Item Name: Crosstube Turning Detail

DRAWING NO. D212-664-241	TITLE CROSSTUBE ASSY (205/212 HI AFT)	REV. D	DART AEROSPACE LTD ENGINEERING ORDER		D.E.O. NO. D212-664-241-D-1	SHEET NO. SHEET 1 OF 2	SCALE NTS
DRAWN	CHECKED	MFG. APPR.	APPROVED	DE APPR.			
DATE 11.04.07	DATE 11.04.11	DATE 11.04.12	DATE 11/04/12	DATE 11.04.12

ADD AN INSPECTION WINDOW TO UNDERSIDE OF CROSSTUBE.

REPLACE MAGNOBOND WITH PROSEAL.

D212-664-241/-241B
ASSEMBLY DETAIL

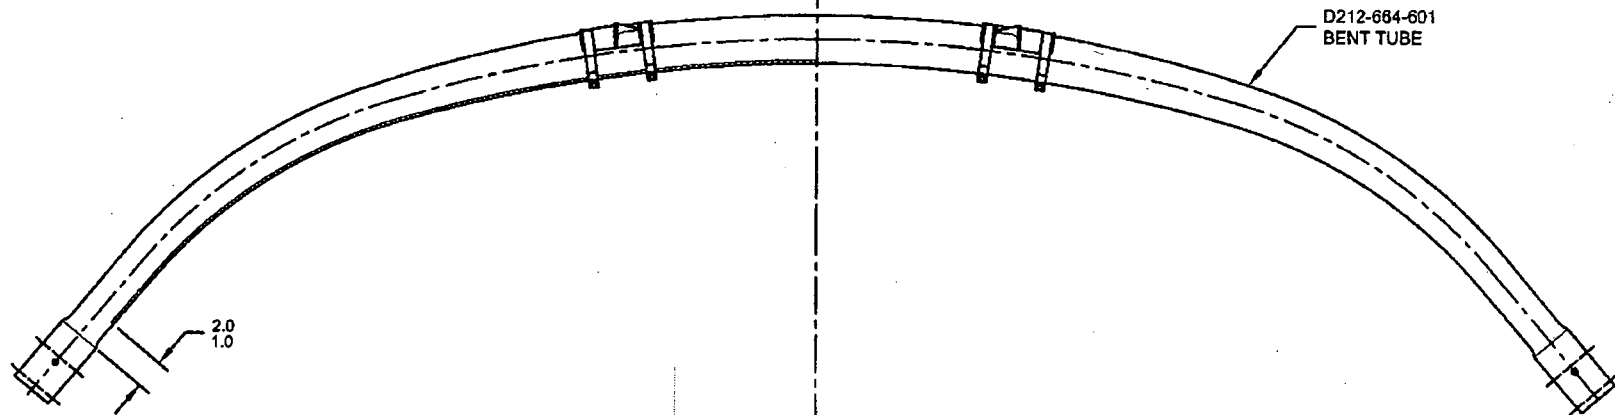
NOTES 2 OF SHEET 1 IS AMENDED AS FOLLOWS:

MASK AREA PRIOR TO PAINTING,
REMOVE MASKING AFTER PAINT
AND APPLY CLEAR COAT

- 2) FINISH: CHEMICAL CONVERSION COAT PER DART QSI 005 4.1
PRIME INSIDE AND OUTSIDE PER DART QSI 005 4.2
MASK UNDERSIDE OF CROSSTUBE AS SHOWN (HATCHED AREA) AND
PAINT OUTSIDE PER DART QSI 005 4.2
REMOVE MASKING AND APPLY CLEAR COAT
